Prairie Island Independent Spent Fuel Storage Installation
Docket 72-10
Renewed Materials License No. SNM-2506

Response to Request for Additional Information: License Amendment Request to Expand the Storage Capacity of the Independent Spent Fuel Storage Installation (ISFSI) (EPID No. L-2019-LLA-0169)

Response to Request for Additional Information

License Amendment Request to Expand the Storage Capacity of the Independent Spent Fuel Storage Installation (ISFSI)

CPT: CPT-01

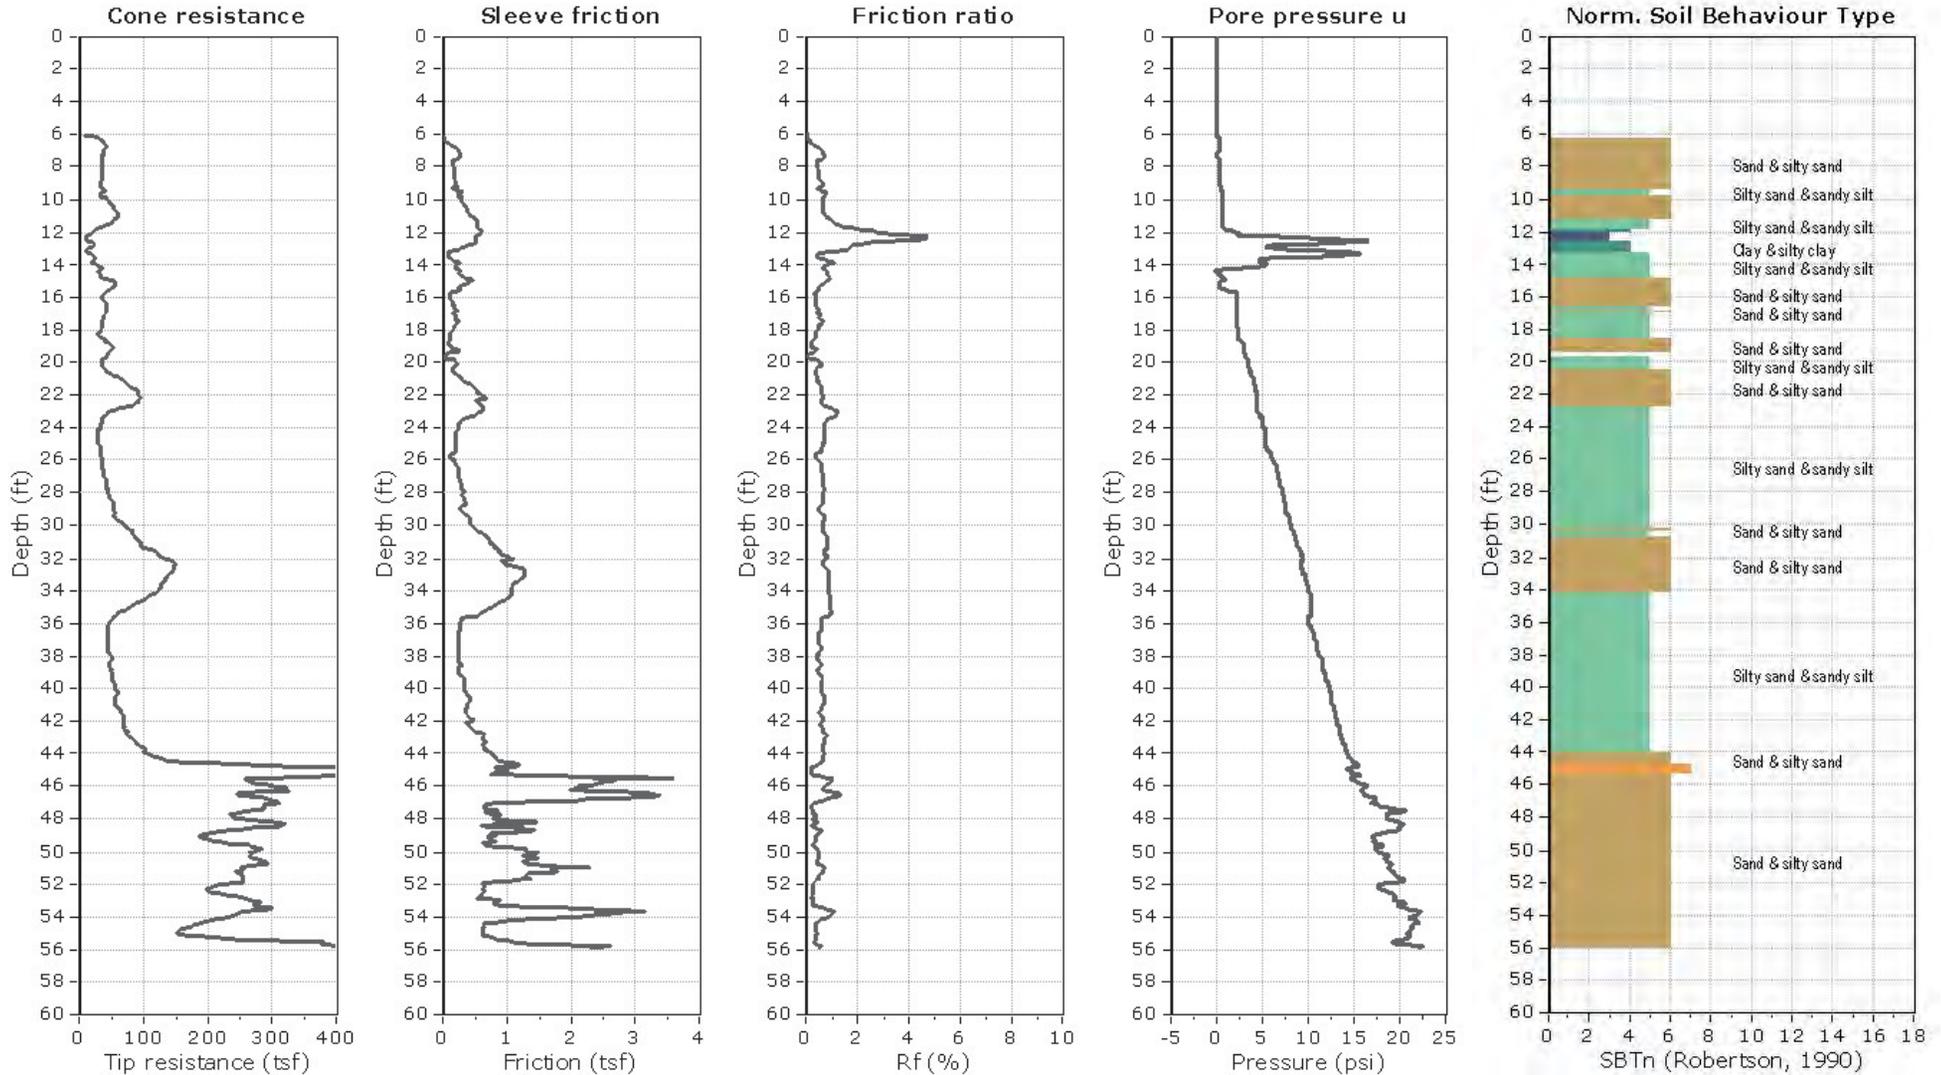
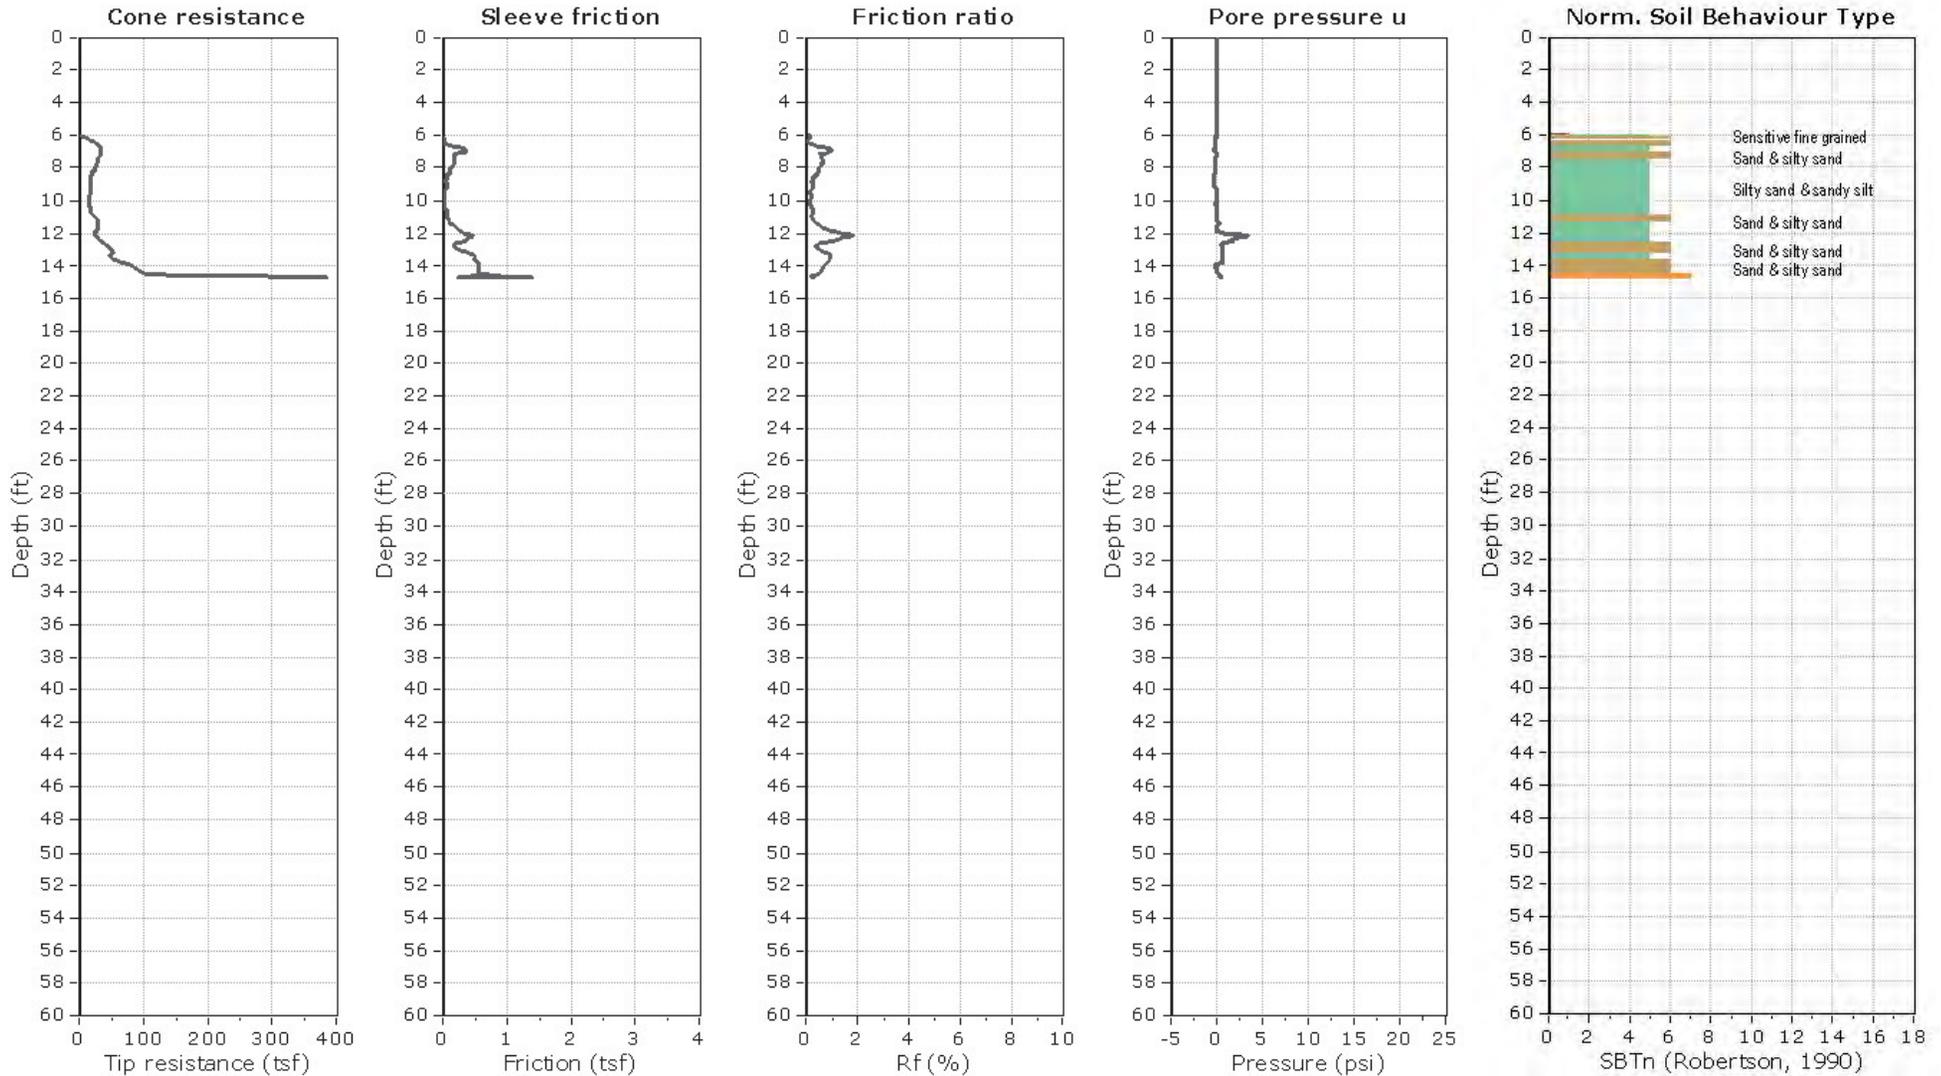
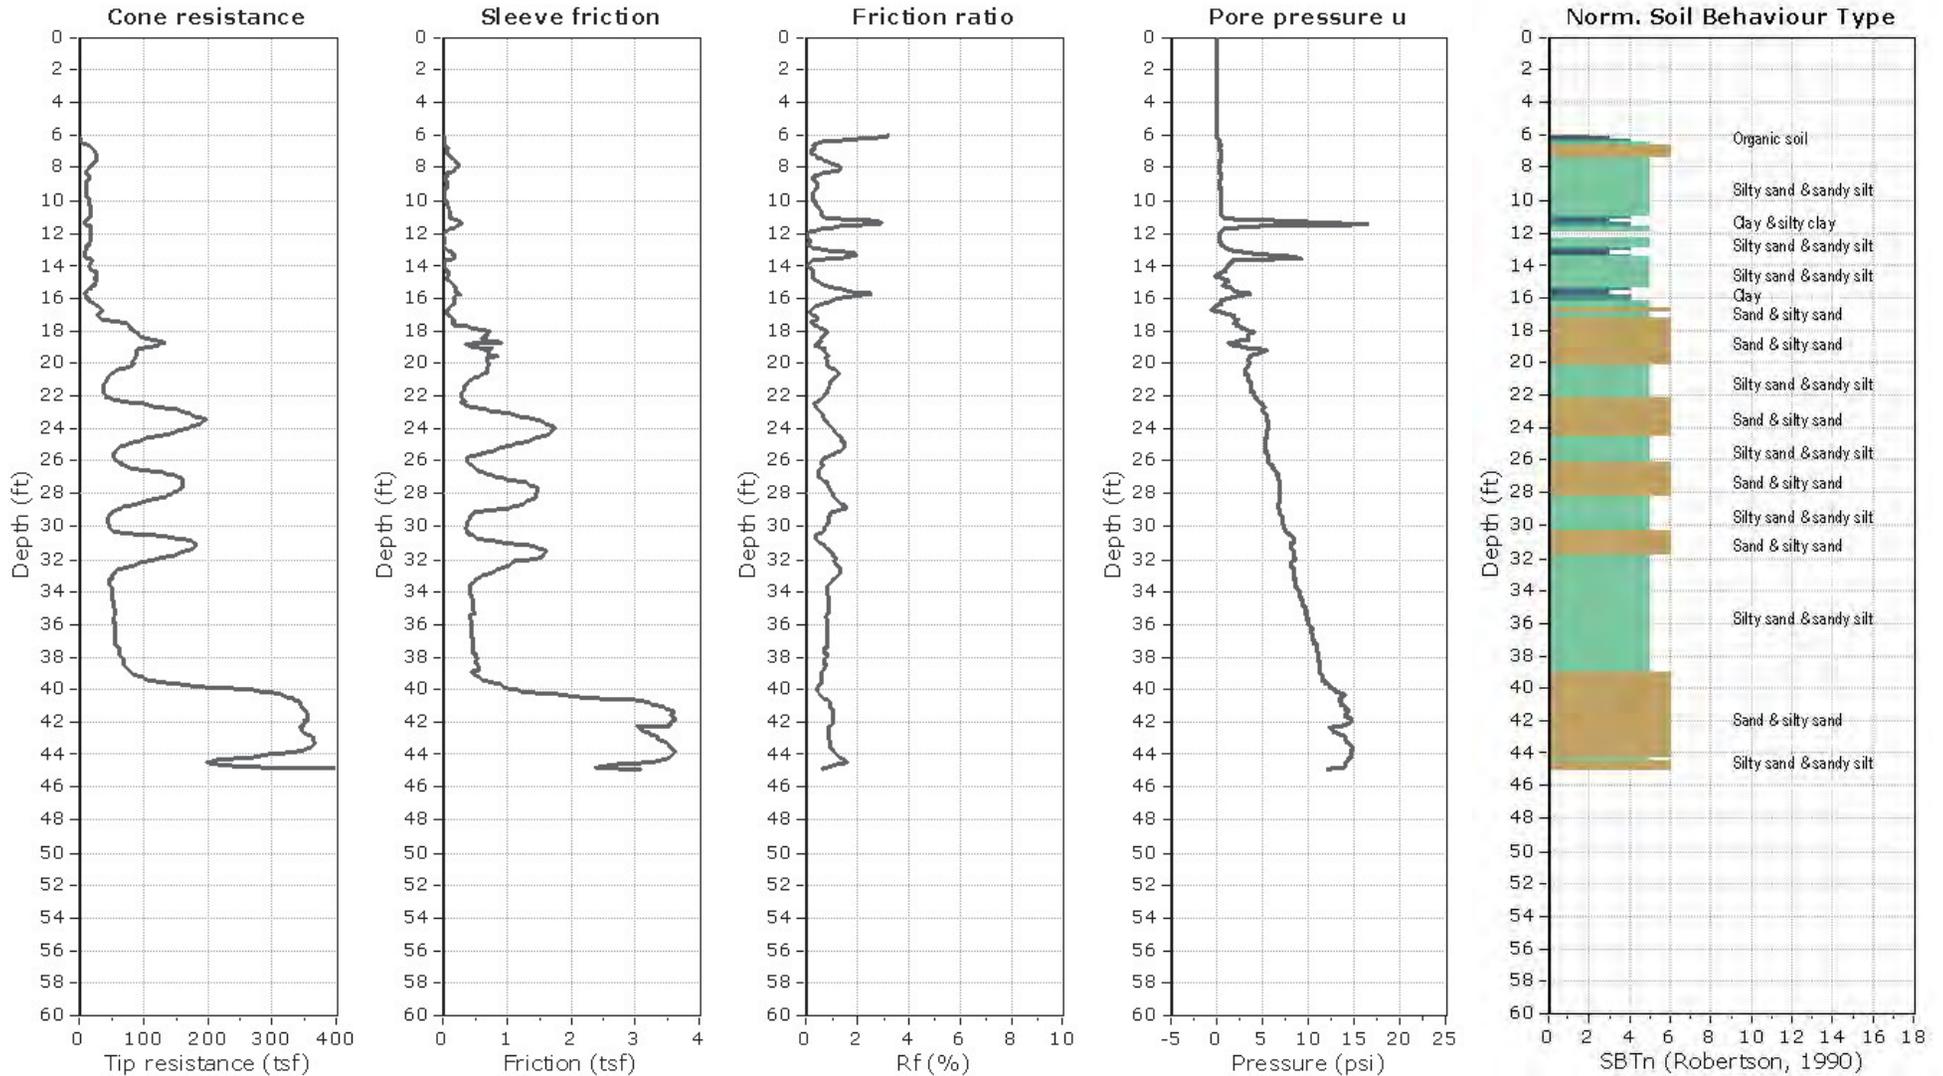
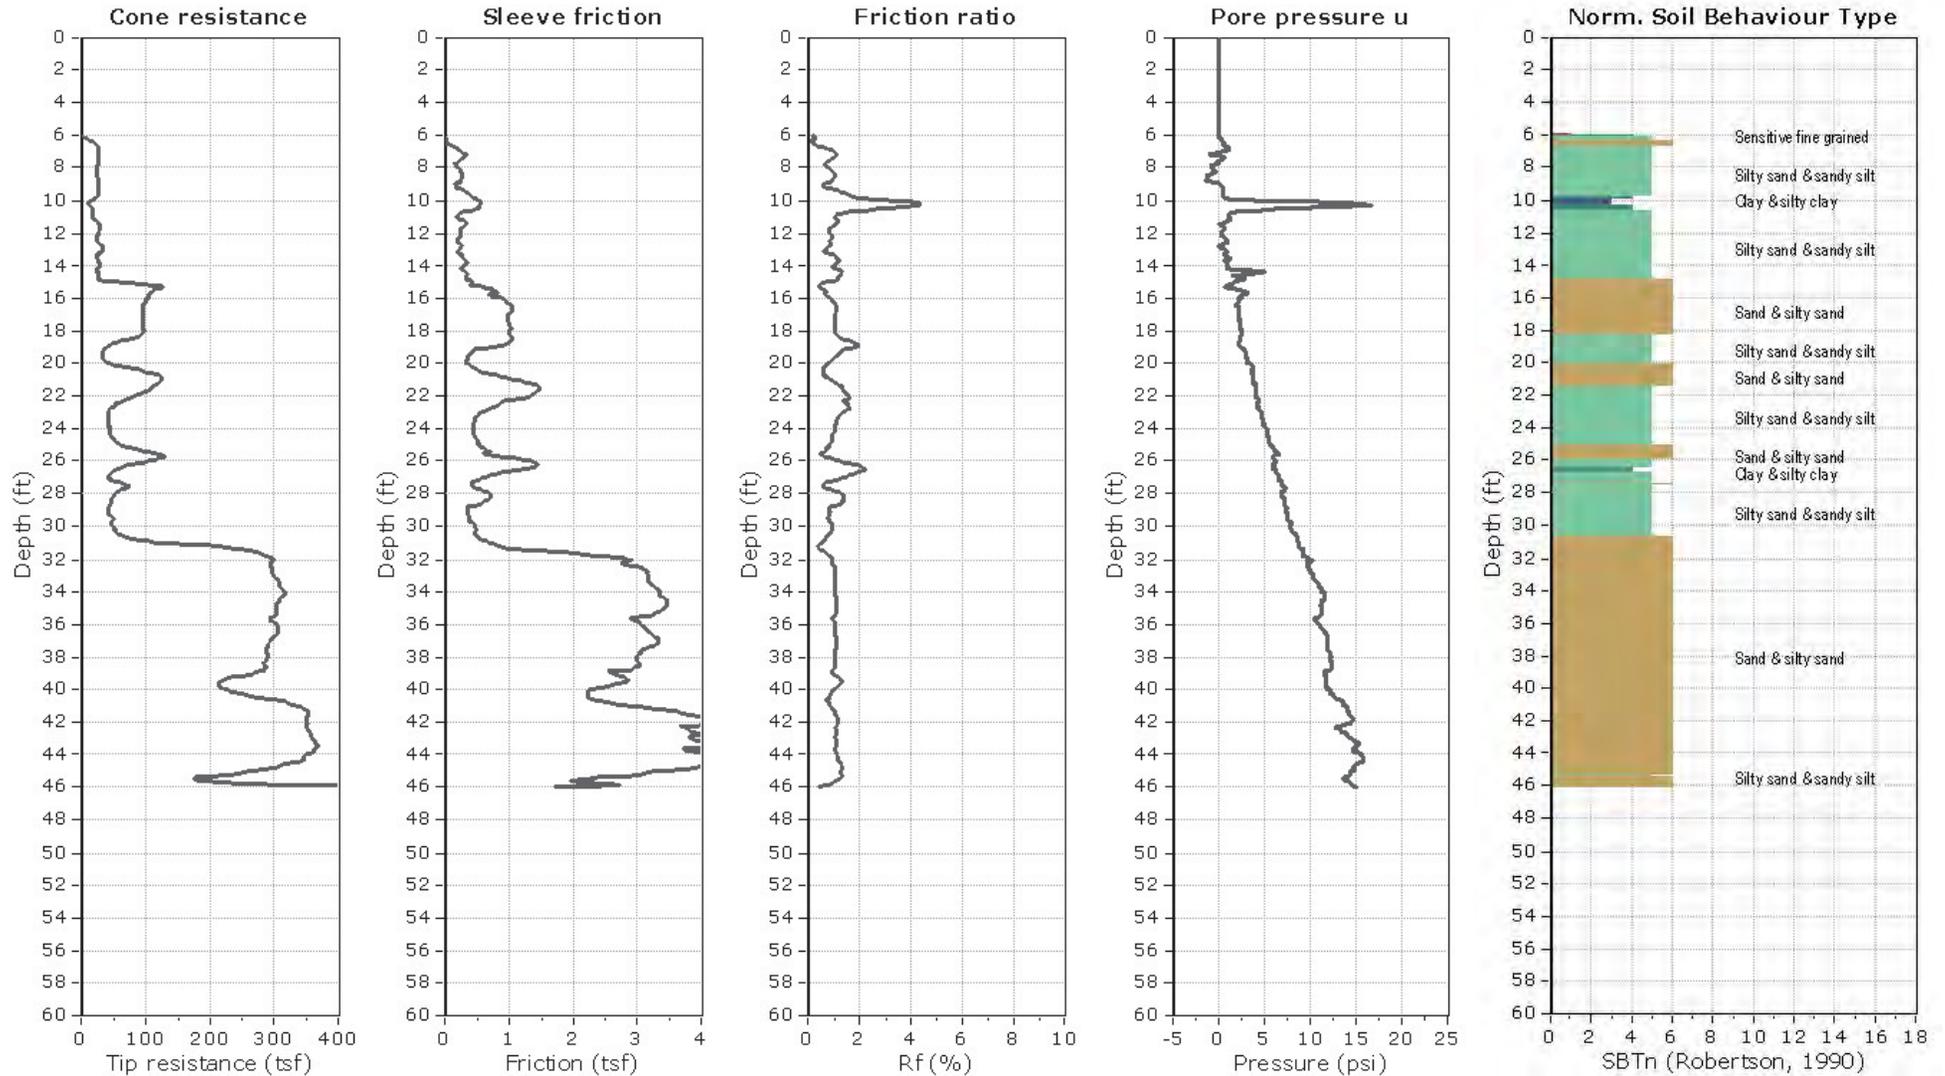
- a. Provide the logs and locations of the Cone Penetrometer Testing (CPT) performed for the proposed ISFSI pad.

As discussed in Reference 1, a series of four cone penetrometer tests (CPT) were used to evaluate the subsurface data for liquefaction potential at the new ISFSI pad location, in conjunction with data from the standard penetration tests (SPT) performed in 1991 for the existing ISFSI pads within the ISFSI area as well as a boring performed in August 2014 to support construction of the nearby FLEX Equipment Storage Building. The CPT locations (CPT-1 through CPT-4) and logs are provided in new Appendix 2C. See Attachment 1 to this Enclosure for the markup to the ISFSI SAR which adds Appendix 2C.
